SERVICE BULLETIN

SB No. 75 Issue No. 1

TITLE INSPECTION OF RUDDER PEDAL SLIDER/HEATER DISTRIBUTION BOX CLEARANCE

APPLICABILITY: All T67M260 and T67M260-T3A aircraft.

FIG 1

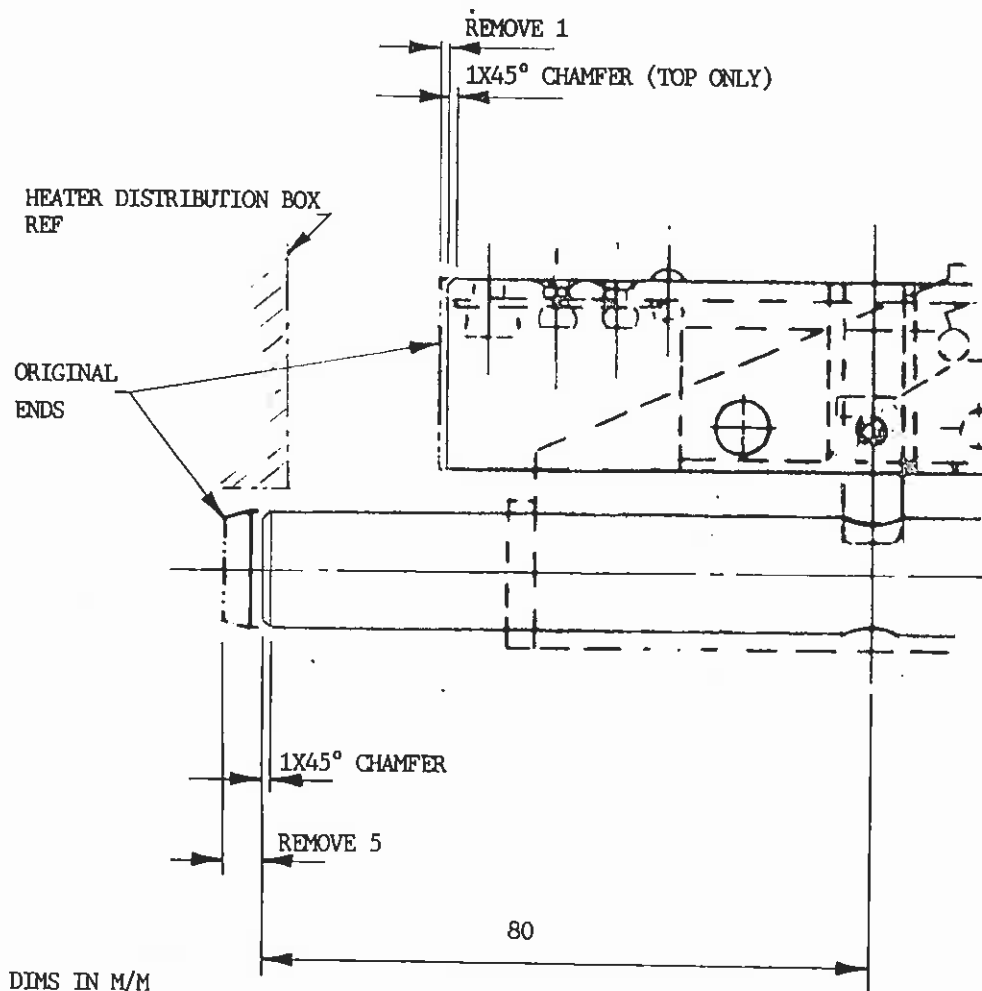
During a post delivery inspection a foul was discovered between the square rudder pedal slider and the heater distribution box, in addition the round slider was found to be close to the heater. The foul occurs when the left hand pilot's right hand pedal (Number 2) is adjusted fully forward with full right rudder deflection. Although a foul may occur there is no possibility of jamming the rudder pedal, only a slight restriction in travel.

1. Check for clearance with No.2 pedal adjusted fully forward, full right rudder whilst applying the brake.
2. Note clearance, 1mm minimum required between square slider and heater distribution box with foot loads applied.
3. If clearance is inadequate, remove pedal assy and modify as per Fig. 1.

Note: Modify both square and round slider.

4. Pedal assy to be re-identified as T67G-45-851 and Mod M663. Annotate Mod M663 incorporated in Log Book.

ETCH PRIME CUT ENDS
